***Planning Department  
Transportation Development Services***

**Re: Starbucks and Burger King, 1000 Rio Grande Blvd. NW**  
**Traffic Circulation Layout**  
Engineer's Stamp dated 01-16-15 (H13-D021)

## 1000 RIO GRANDE BLVD., NW SITE PLAN FOR BUILDING PERMIT

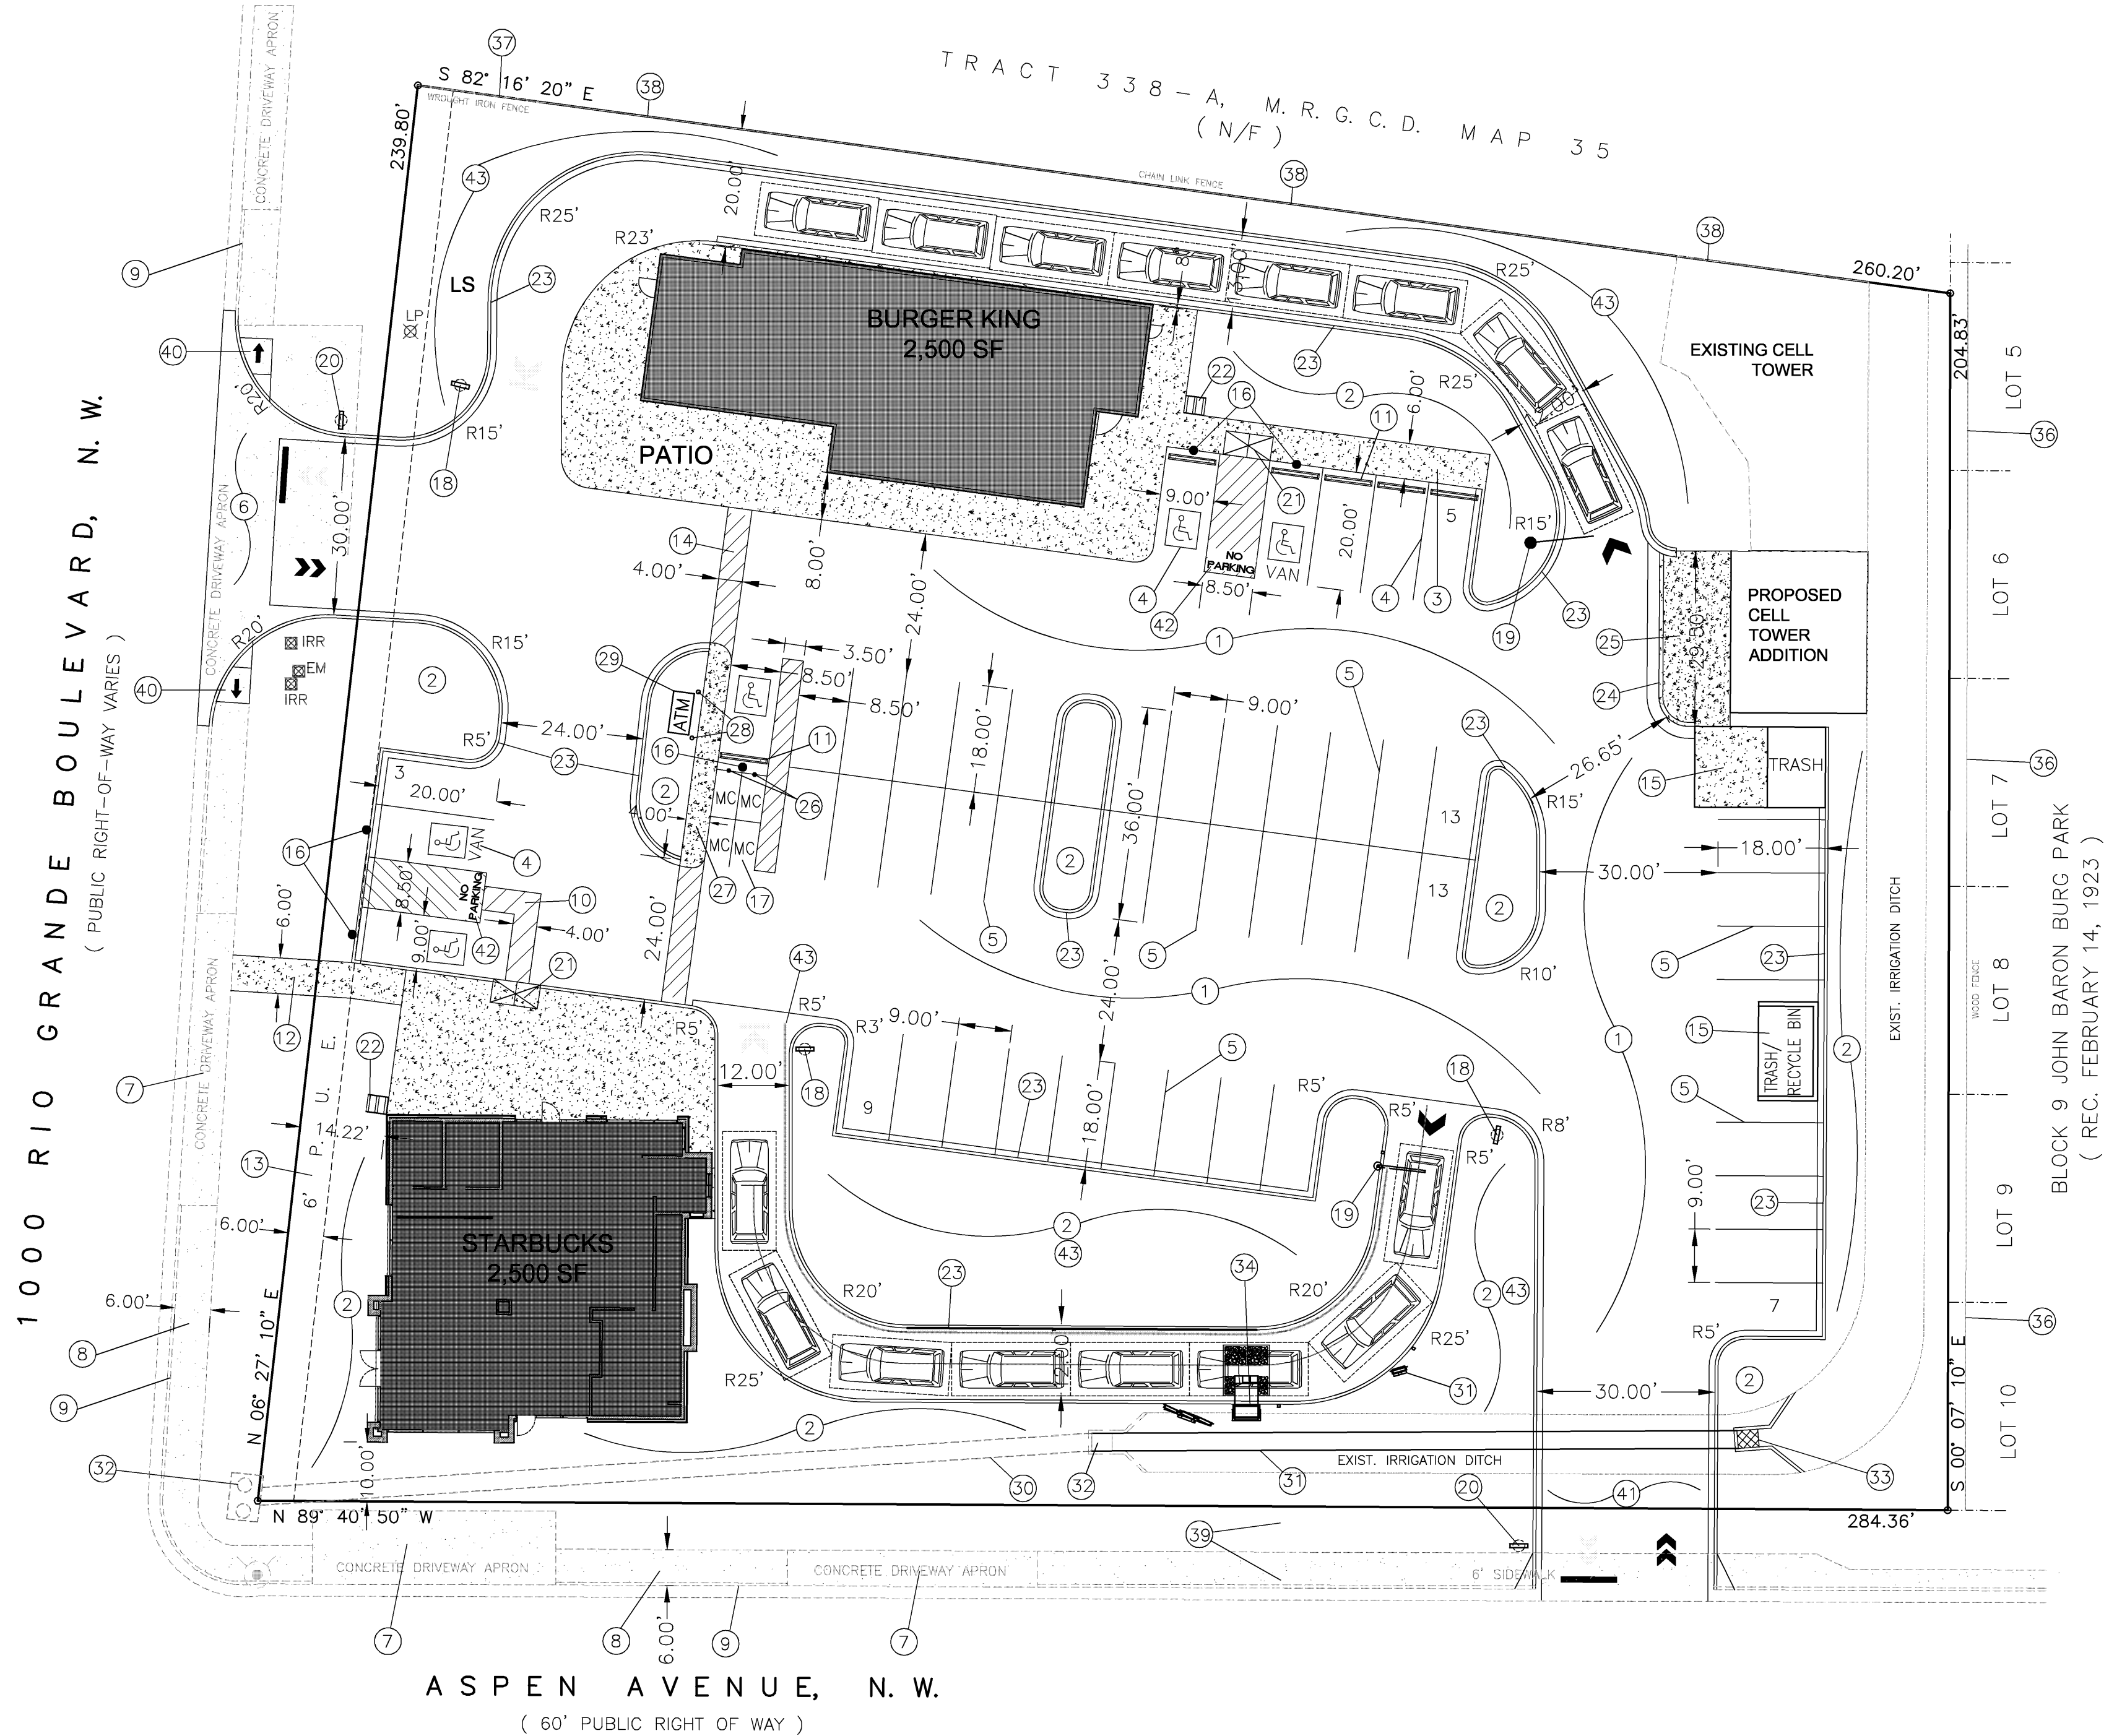
2. Label existing curb ramp at the corner of Aspen Avenue and Rio Grande Blvd. Call out for it to remain undisturbed.
3. Label curb radii for all dead-end islands. Radii needs to be a minimum of 15 feet for passenger cars (See Figure 23.7.2, Page 23-88 of DPM.). For the southeast corner of the site development, radii of 10 feet and 8 feet are shown, and they need to be increased to 15 feet.

4. Please show and label the Aspen Avenue/23<sup>rd</sup> Street intersection to show the proximity of new drivepad location to this intersection.
5. The drive onto Rio Grande Blvd. does not meet the required queuing throat length for an arterial street (Table 23.7.1, page 23-91). The throat will have to be lengthened. It's best to call and discuss this comment.

6. The design delivery route for the larger delivery vehicles needs to be shown.
7. At the northwest corner of Burger King, add curb or barrier to separate pedestrian traffic from vehicular traffic where the radius of 23 feet is shown.

8. For Notes 14, 10 and 27, increase the width of the ADA accessible route from 4 feet to 6 feet. Per the DPM, a 6-foot wide ADA accessible pedestrian pathway is required from the HC parking stall access aisles to the building entrances.

10. Show the mini clear sight distance triangle per page 23-74 of the DPM for the drivepad onto Aspen. Please add the following note to this clear sight triangle: "Landscaping and signage will not interfere with clear sight requirements. Therefore, signs, walls, trees, and shrubbery between 3 and 8 feet tall (as measured from the gutter pan) will not be acceptable in this area."

11. For the new site drive onto Rio Grande Boulevard, provide a clear sight triangle that is in compliance with Page 23-28 of the DPM for intersections. Also add the note "Landscaping and signage will not interfere with clear sight requirements. Therefore, signs, walls, trees, and shrubbery between 3 and 8 feet tall (as measured from the gutter pan) will not be acceptable in this area."

12. To provide further clarification for the queuing length for the vehicles, list the total length of the queue for both the Burger King and the Starbucks drive-thru on the site plan view.

13. For Keyed Note 7, please list the length for each one of the curb cut removals and replacements on the plan view.
14. Near Keyed Note 9, call out the existing sidewalk width. For Keyed Note 8, have call-out note saying that existing sidewalk is to remain undisturbed. Make sure Keyed Note 8 is called out on all areas in between existing curb cuts where sidewalk is supposed to remain undisturbed.

15. For the 6-foot sidewalk tie-in to existing sidewalk on Rio Grande Boulevard, call out for a smooth tie-in.
16. For the uni-directional ramps shown as part of Keyed Note 40 for the drive onto Rio Grande Boulevard, provide detail complete with detectable warning devices.

17. For Keyed Note 21, provide a ramp detail.
18. For the aisle for handicapped parking in the center of the parking lot, increase from 3.5 feet to the required minimum width of 5 feet. If it helps, in order to gain this extra width for this aisle, parking spaces only need to be a minimum width of 8.5 feet.
